## Rear Shelf Speaker Aperture Modification

### Background

### **Early Nissan Bluebird**

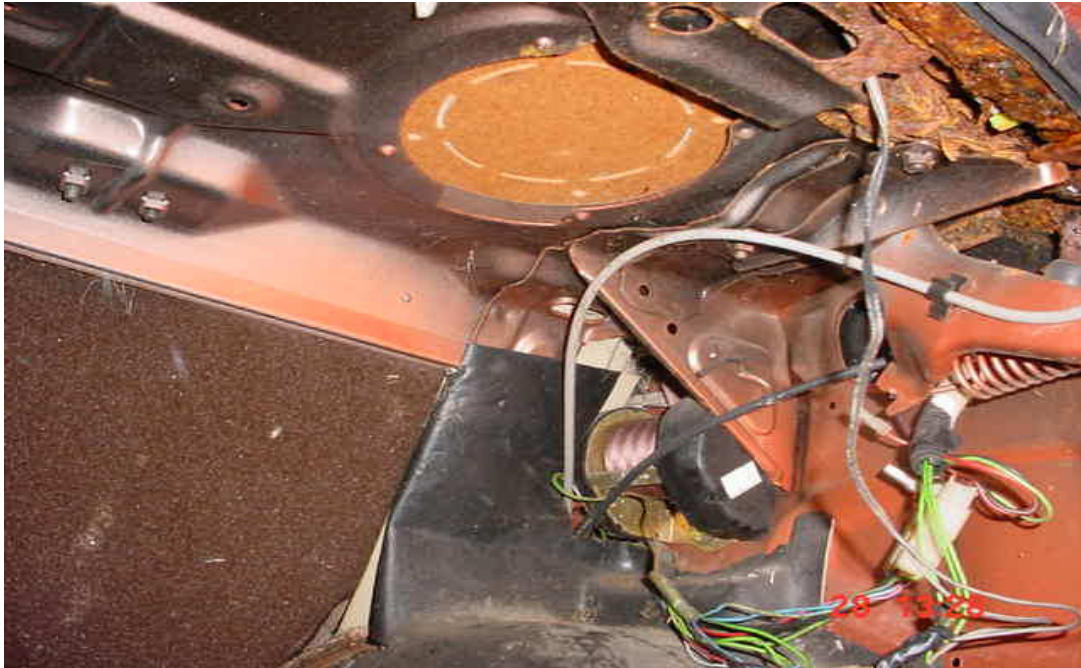
This Nissan Bluebird static anchorage would pull forwards on the C-pillar and inwards during an impact. The sheet metal structure forming the rear of the seat would still provide support to the C-pillar's inward loading, even if the rear shelf speaker aperture were to be enlarged.
